COUNCIL ASSESSMENT REPORT

Parramatta City Council

File No: DA/131/2016

Panel Reference	JRPP Reference Number: 2016SYW043
DA Number	DA/131/2016
LGA	City of Parramatta Council
Proposed Development	<p>Construction of a four storey school building in association with an existing Educational Establishment known as the Maronite College of the Holy Family involving:</p> <p>*Demolition of an existing residential flat building at No.63 Weston Street, boundary fencing and demolition work to the eastern side of existing Block B and changes to ground levels;</p> <p>*Construction of a four storey addition with roof terrace to the east of Block B containing reception and office space, student amenities, general learning areas (GLAs) and outdoor play areas;</p> <p>* Landscape works including the removal of three trees along the eastern boundary, new landscaping along the Weston Street front setback and the eastern boundary, border planting on the new roof terrace;</p> <p>* Signage along the southern elevation of the new addition; and</p> <p>* Use of the building for the purposes of an Educational Establishment.</p>

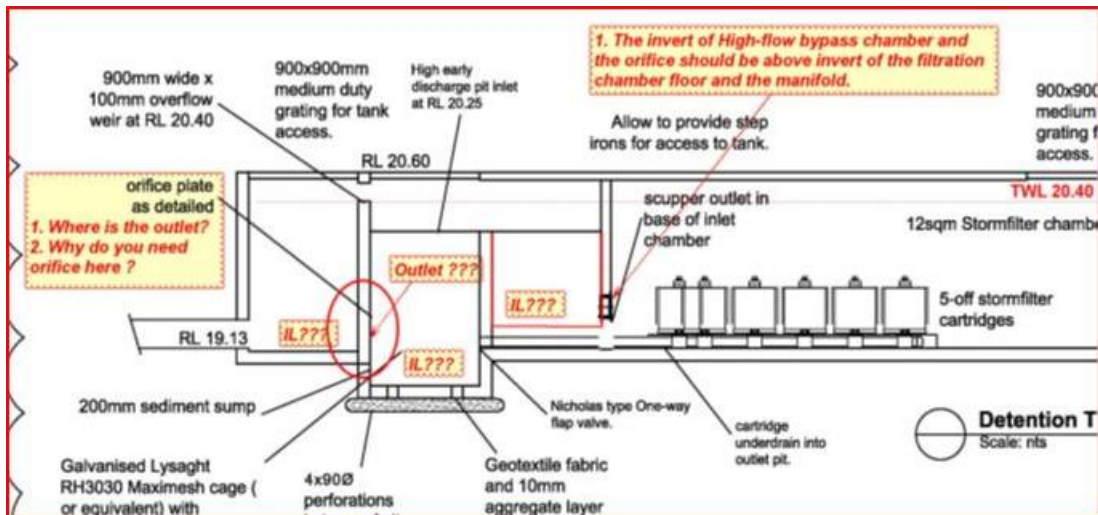
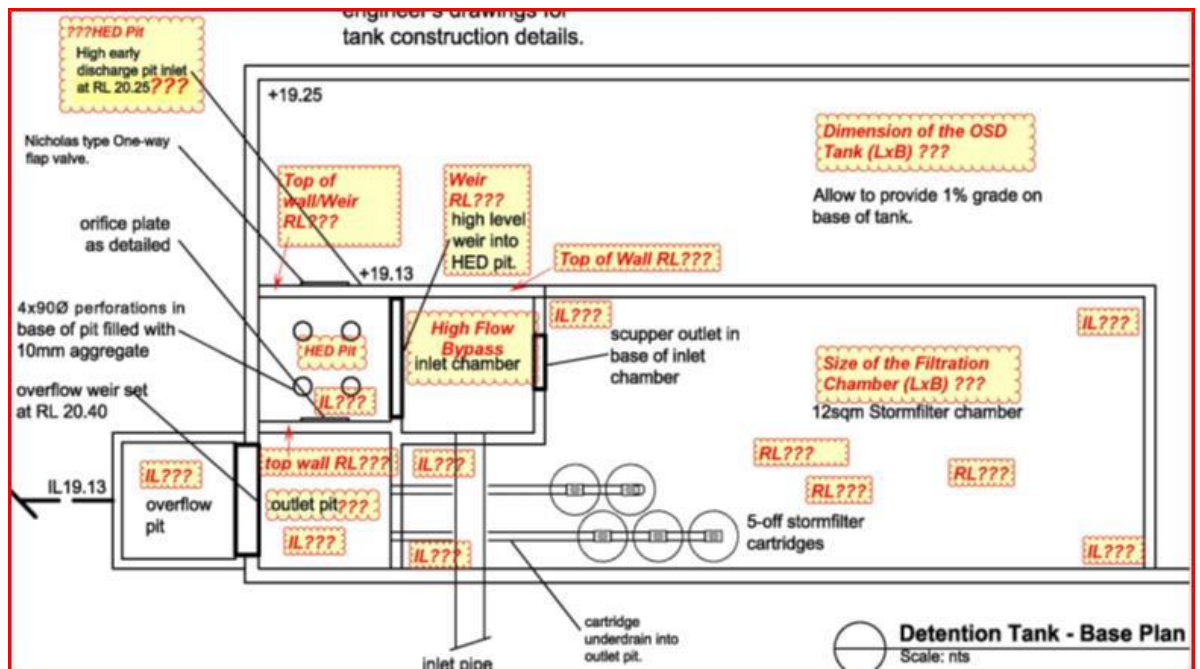
There were few issues noted with the earlier versions of the Stormwater management proposal. The submitted stormwater plan intends to incorporate the necessary

amendments in an attempt to address those issues. However, the final plan (Revision "D") still does not appear to have fully addressed the issues. The following are the outlines of the issues and necessary amendments.

4. It is noted that the "Outlet Pit" does not have any practical function and appears to be redundant. Hence, it should be deleted.
5. The Top of wall (weir) surface level (RL) between the OSD storage area and the HED pit is unclear/ missing. The weir should be at **RL20.25m** (not the inlet as shown on the plan).

7. For clarity of the drawing, other sectional details with associated levels (invert/ orifice centre/ surface etc.) and dimensions are needed
 - Another Long-sectional details through the overflow pit, outlet pit and filtration chamber showing the levels is needed.

- Transverse section through the Storage area, HED control pit with orifice, and the overflow pit,

- The sectional planes should be marked on the layout plan.

Planning Comment: Council's engineer recommended a deferred commencement stormwater condition. The condition recommended is highly prescriptive and can be applied prior to construction certificate with certainty. Subject to recommended conditions the proposal is satisfactory.
